Subject: Duke Power Company LLC d/b/a Duke Energy
Carolinas, LLC (Duke)
Catawba Nuclear Station, Unit 1
Docket Number 50-413
Request for Relief Number 05-CN-004
Reply to NRC Request for Additional Information
(TAC Number MC8337)

REPLY TO NRC REQUEST FOR ADDITIONAL INFORMATION

Notes for Clarification on Catawba, Unit 1
Request for Relief 05-CN-004, Revision 0
TAC MC8337

SHEET TITLE: OUTLET SAFE END DETECTION AND SIZING

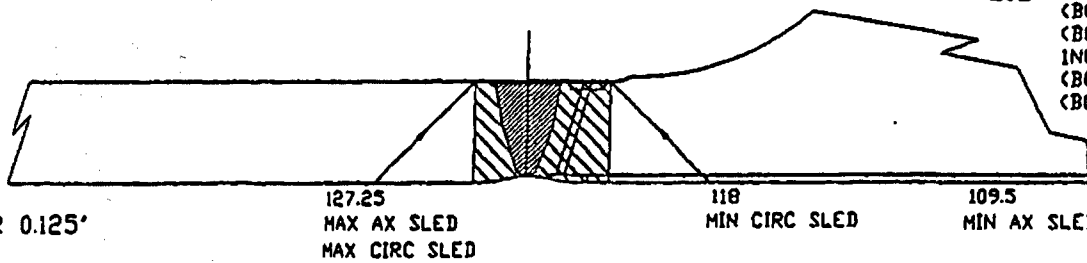
- 2) Request for Relief 05-CN-004, Item 7 covers dissimilar metal welds on the RPV primary outlet nozzle-to-safe end (Examination Category B-F, Items B5.10 and B5.130, as listed by the licensee).
- a) It is not clear from the sketches provided by the licensee that weld 1NC23-01 is a dissimilar metal weld. This weld appears to be a wrought stainless steel (safe end) to stainless steel (piping) weld.

Please confirm this configuration. If this is indeed a safe end to pipe weld, this should be Examination Category B-J, Item B9.11 (see discussion below).

- c) The licensee's submittal (Adobe PDF file) is missing Page 3 of 3 in Attachment G, which should help explain the coverage for these welds. Please submit this page.

Note that there are two (2) welds within close proximity to each other at this and similar Reactor Vessel Loop locations. There is a B-F weld of wrought stainless steel safe-end to cast stainless steel weld and a carbon steel vessel nozzle to wrought stainless steel safe-end.

The missing page is provided herein.
